Report on
Geotechnical Stability Review

Tomingley Gold Extension Project
Newell Highway, Tomingley

Prepared for
Department of Planning & Environment (NSW)

Project 217140.00
September 2022

Figure 1: Comparison of structures geophysics (left) and logged in cores (right)

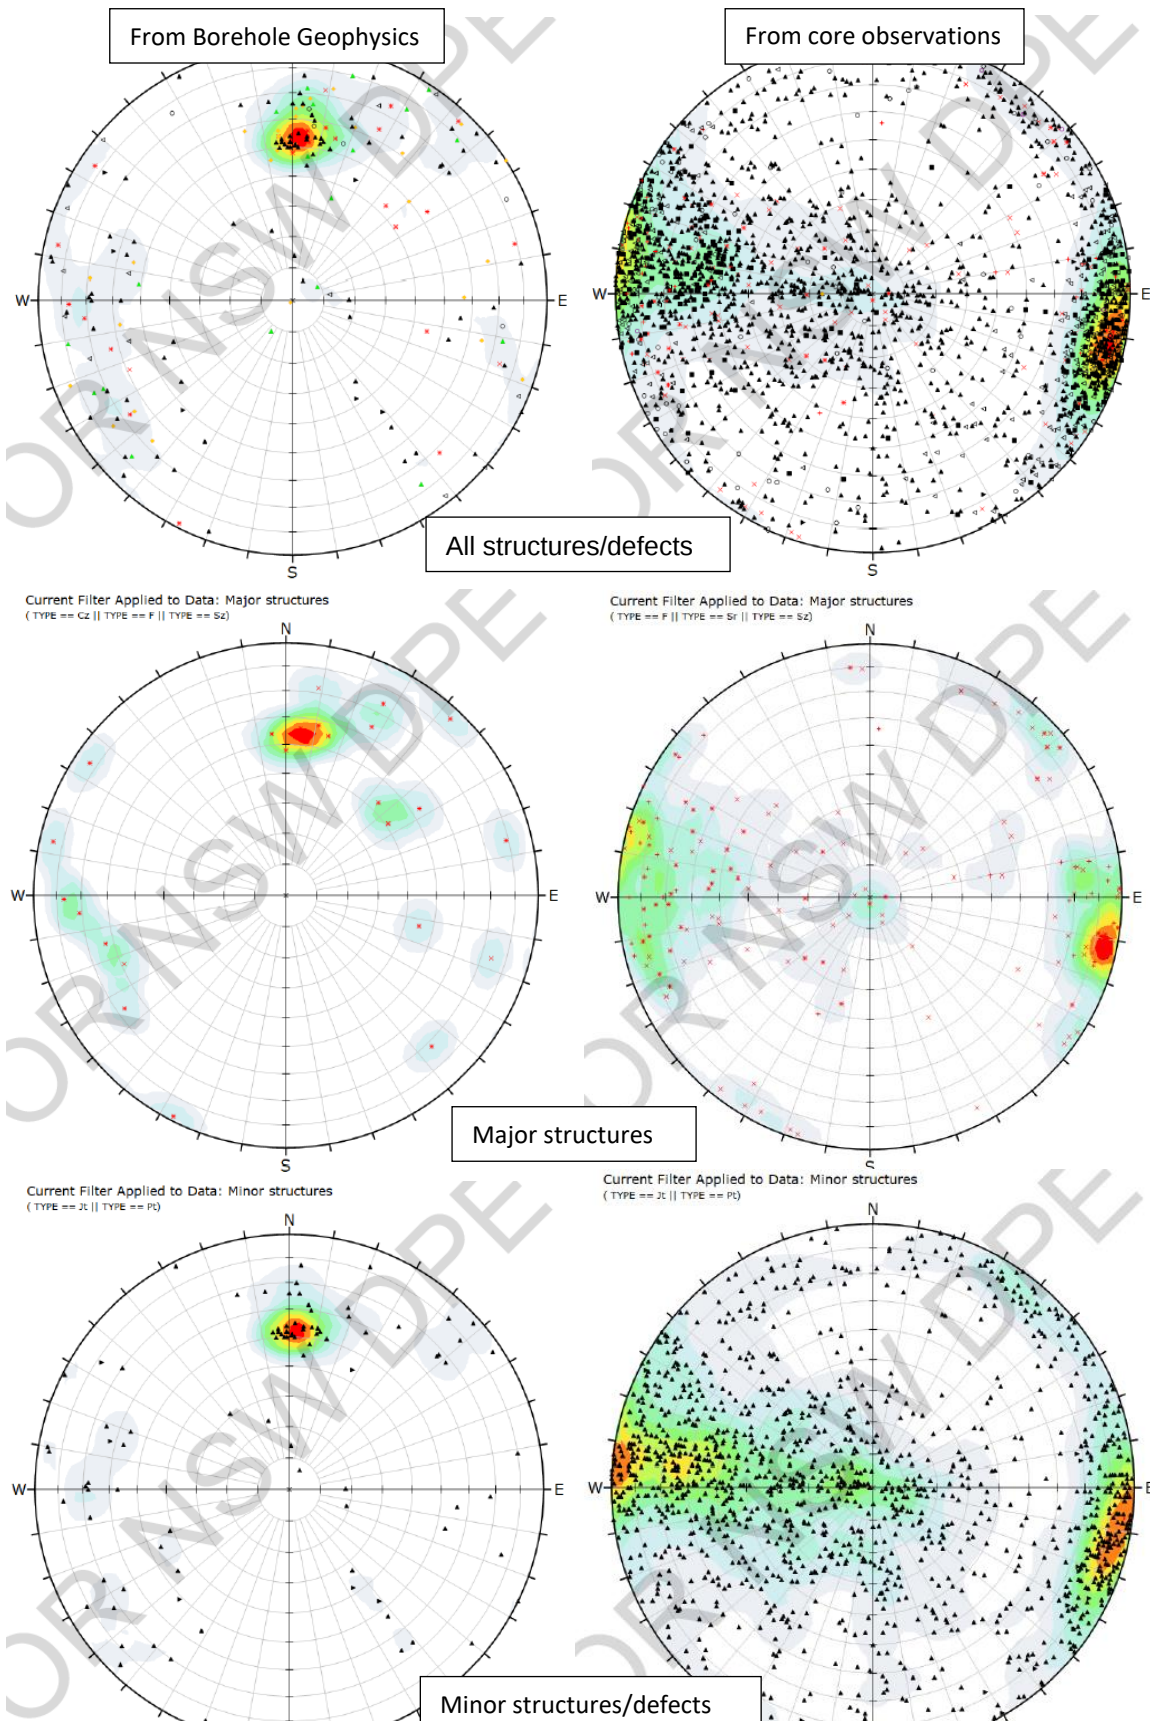
There is nothing in the report to suggest that the two sources of the same structural data (ie borehole geophysics and bore core features) were combined, or even cross referenced, and instead the two interpretations are presented separately. Figure 1 (below) compares the stereoplots for the full data from each source, and plots the data separated into major and minor structures. It is clear from this comparison that there is little or no correlation between the data derived from the two sources. Whilst perfect correlation would be unexpected, an absence of meaningful correlation is concerning, and it suggests that one or both methods are inherently flawed. The report notes that “the success of the downhole geophysics was poor due to many holes being blocked” and due to poor image quality in the more weathered materials. However, no evaluation is provided for the likely sources of the inconsistency between data from different sources, which is likely to be reliable/more reliable, and how the identified significant structural features to be used in design were selected from the data.

The data from the logged defects and structures in the boreholes would seem to be more consistent with the regional geological structure, as it has been summarised elsewhere. It might also be suspected that the source of the data inconsistency could lie in errors associated with orientating data in inclined boreholes and correcting it to dips and dip directions relative to vertical and horizontal axes. This again highlights the importance of outlining the approach and processes used. It is noted that the bore core data used was a combination of features from the SAR series of boreholes drilled for this report, and features in exploration boreholes drilled by the mine. It would be useful, in evaluating the reliability of the structural data, to present a comparison of these two sets of somewhat independent data, to confirm that the general trends were not systematically different.

Figure 2: Structural features displayed in the existing Wyoming One pit showing different degrees of importance for rock slope behaviour

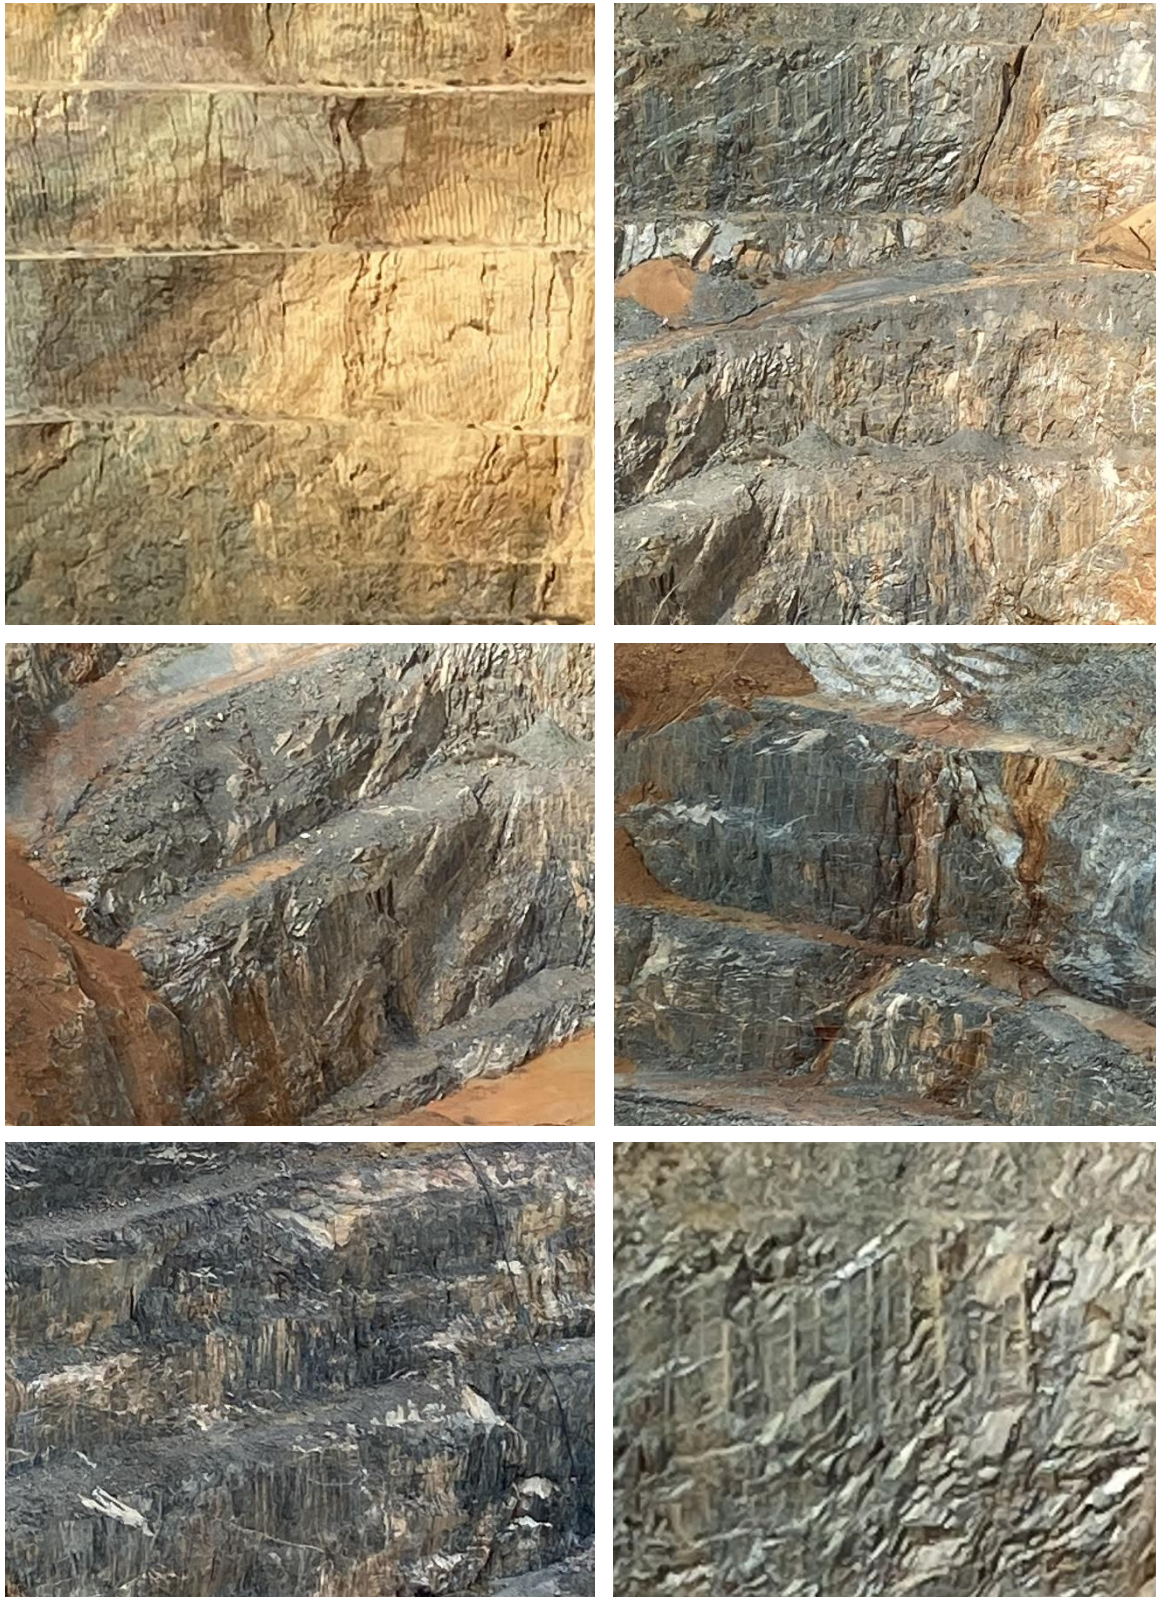
It is surprising to not see a summary or inventory of major structural features that express, or have historically caused problems, for the existing Caloma and Wyoming pits. It was apparent from the site visit that these pits afford the best opportunity to display likely geological structures on a regional scale. Figure 2 (below) presents a selection of images taken of the Wyoming One pit walls during the site visit on 22 August 2022, which show a selection of obvious structural features with varying potential significance for the rock slope behaviour. Structural characterisation from photogrammetric models derived from images captured by UAV have all but become standard practice, and could have provided invaluable data for resolving inconsistencies in the structural trends. Whilst structures in the existing pits may or may not express exactly the same in the proposed SAR pits, it would seem to be of value to at least look for previously encountered structural trends in the SAR pits, to identify which of these are present, and specifically look for and eliminate those that are not. Given the broad scatter of the data in Figure 13 of the report, it is quite possible that important specific structures have been missed. Experience with structures in the Caloma and Wyoming that have been identified the SAR pits would be insightful in quantifying their likely potential impact.

Figure 5: Predictions of pit slope profile evolution from the Landloch report.

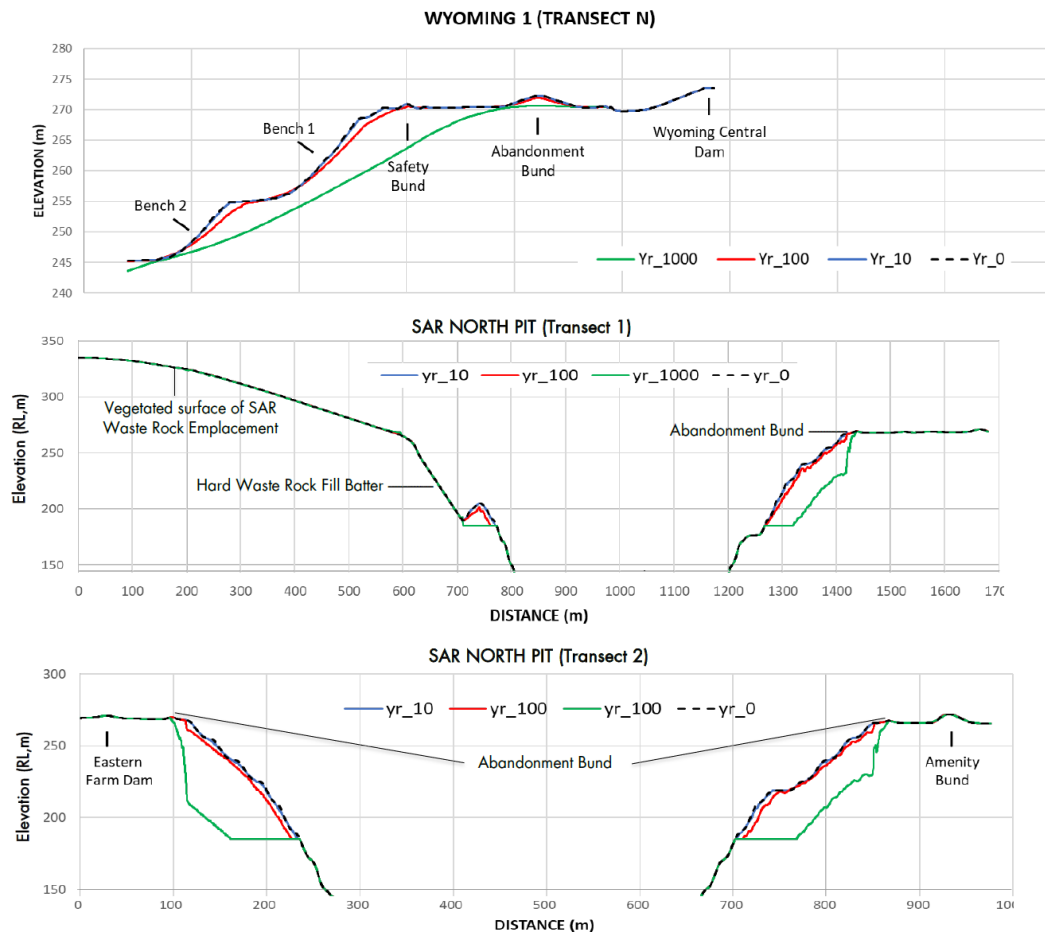
The predictions for the slopes of the WY1 pit seem plausible, showing smoothing and flattening of the slopes within the alluvium and saprolite lithologies. No indication is given as to how these profiles integrate with slope that continues into the underlying bedrock, however, it is noted that the modelled thickness of alluvium and saprolite are between 25 m and 40 m which may be less than the maximum thicknesses of 60 m - 70 m that do occur around the pit. This could affect the predicted slope crest retreat distances.

By contrast, the predictions for the slopes in the same materials of the SAR north pit are very different and indeed, seem improbable. It is difficult to understand how 1000 years of erosion in the alluvium could result in near vertical slopes. Perhaps there are constraints and assumptions in the models used that can justifiably result in the profiles shown, but they were not apparent from the text of the report.
